BIDDERS BULLETIN

PROJECT: Bertrand Public Schools – 2013 Library Renovation
Bertrand, Nebraska

BB-2

DATE ISSUED: March 14, 2013

DATE: March 14th, 2013
DRAWING: A102-3
FROM SHEET: A102

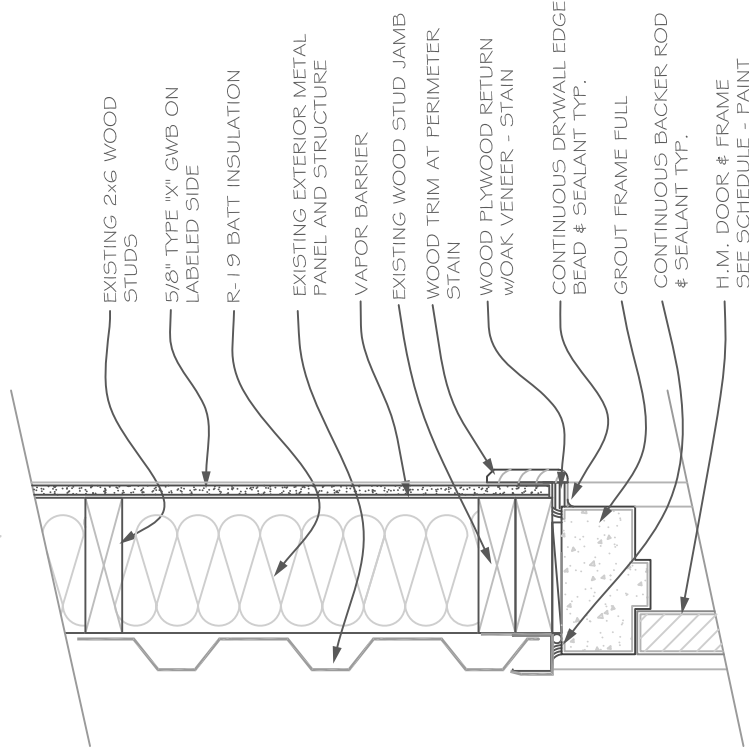
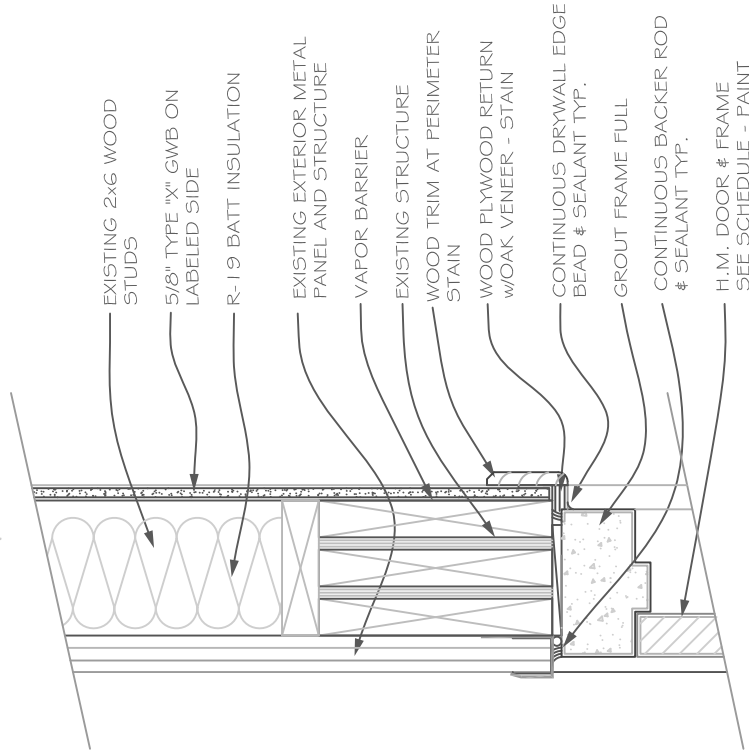
2. Revise detail D1/A102, D2/A102, D15/A102, D16/A102 and D17/A102 per attachments A102-3, A102-4 and A102-5.
3. At detail D4/A102 include sound batt insulation in the horizontal metal studs.
4. At detail D4/A102 add a note to read: "Brace metal studs above window system at Alcoves 103 & 104 with 3 5/8" studs 24" o.c. from bottom of soffit wall at 45° to existing roof deck (towards Exg. Corridor 105).

DATE: March 14th, 2013
DRAWING: A102-5
FROM SHEET: A102

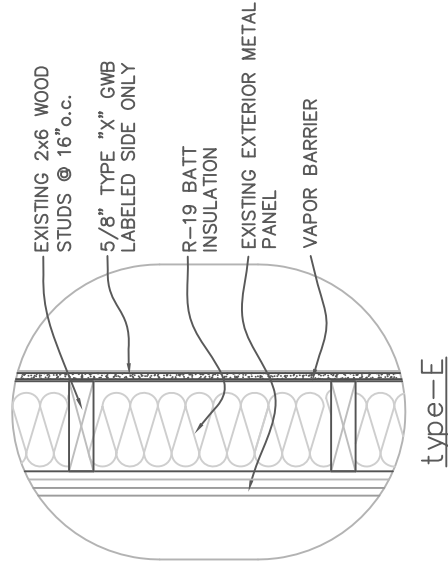
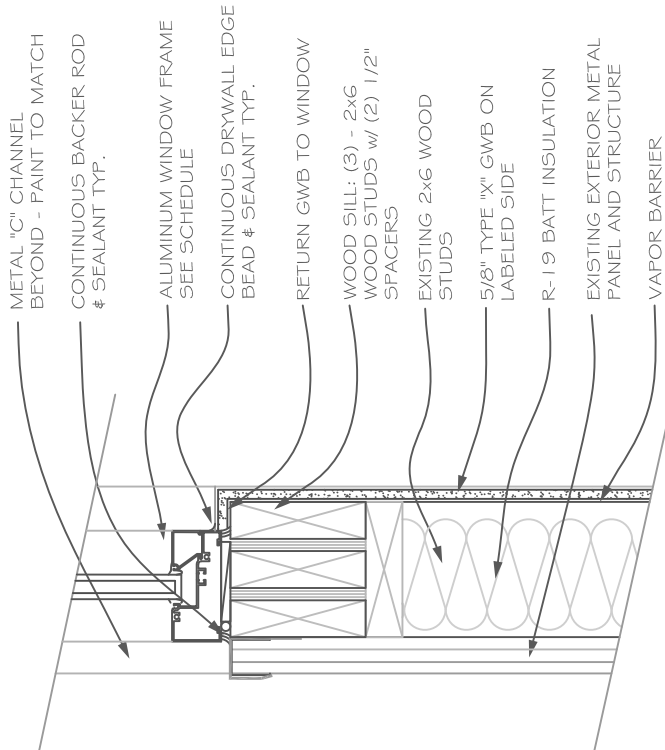
5. Add a note at Wall Partition Types "A" and "C" to read: "One-Hour Wall. This wall to be constructed at the beginning of the project per General Note #11 on sheet A100." (included in this Bid Bulletin)
6. Add a note at Wall Partition Types "B" to read: "One-Hour Wall."
7. Revise Wall Partition Types "E" per attachment A102-5.
